CHRISTCHURCH CITY COUNCIL SUPPLEMENTARY AGENDA

Re: Approval for New Location of Spire Sculpture in Latimer Square

Spire sculpture in Latimer Square

Figure 1
Original Location

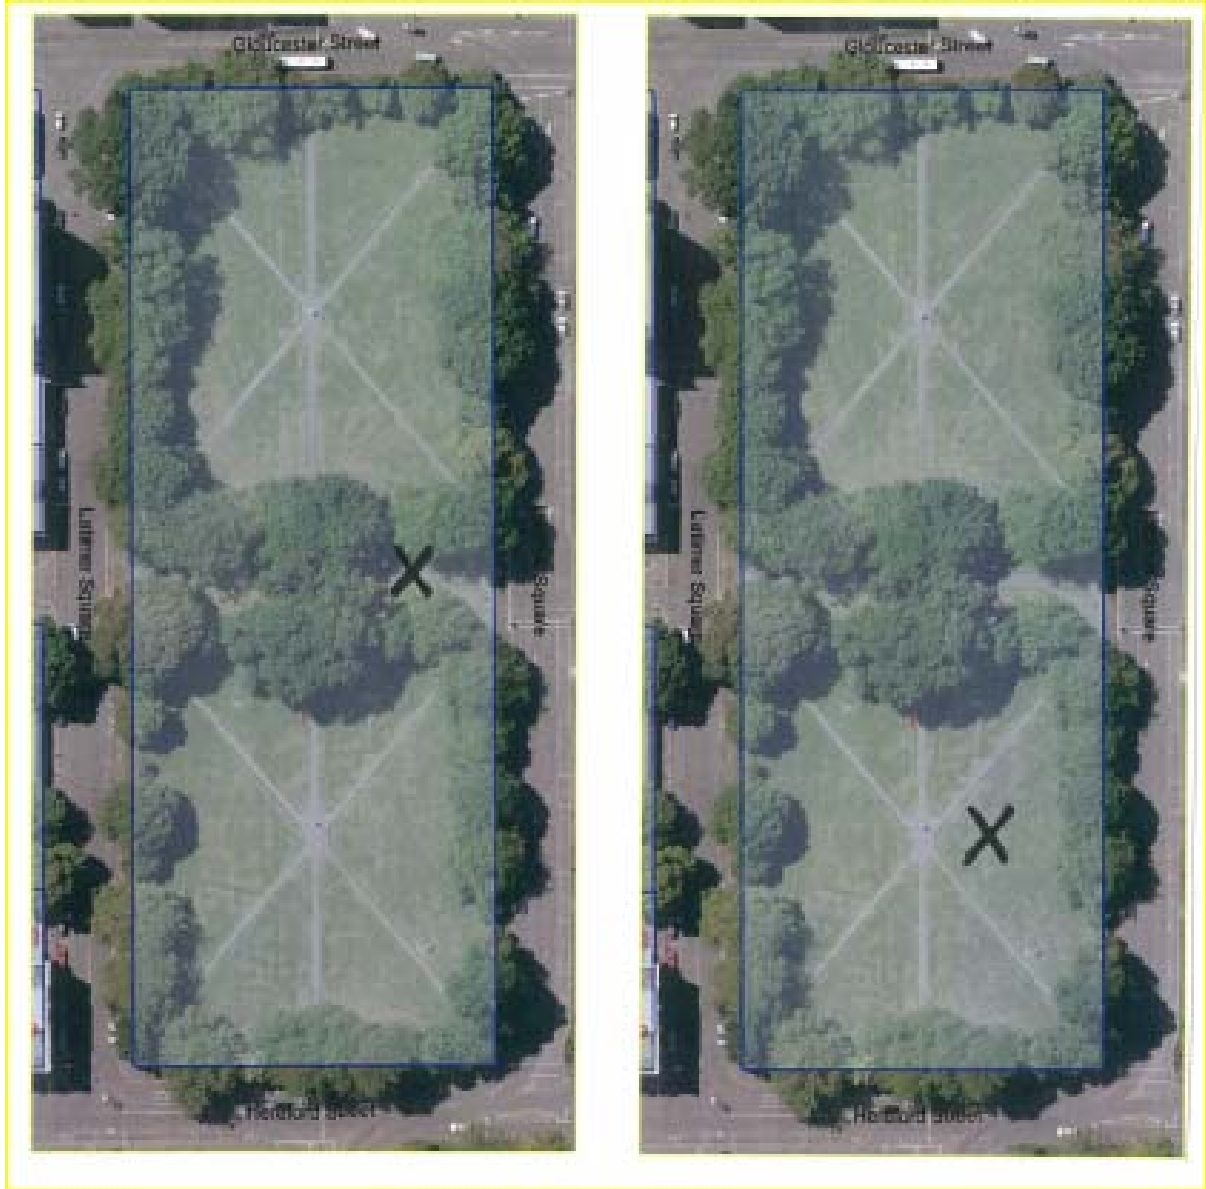
Upon further investigation of the approved location for the Spire Sculpture, Lewis Bradford Consulting Engineers have found that the site has gas, high voltage cables and fibre optic cables within the vicinity of the proposed foundations for the sculpture (refer Figure 1).

Taking into consideration the numerous underground services within the area for the proposed sculpture foundations, Lewis Bradford Consulting Engineers have requested that an alternative location be considered (refer Figure 2).

The alternative location is on the south eastern side, of the southern square in Latimer Square. This proposed location is clear of any services, approximately 5 metres to nearest pipe, and away from any trees.

That the Council approve the revised location for the 'spire' sculpture in the southern square of Latimer Square (as shown in Figure 2).
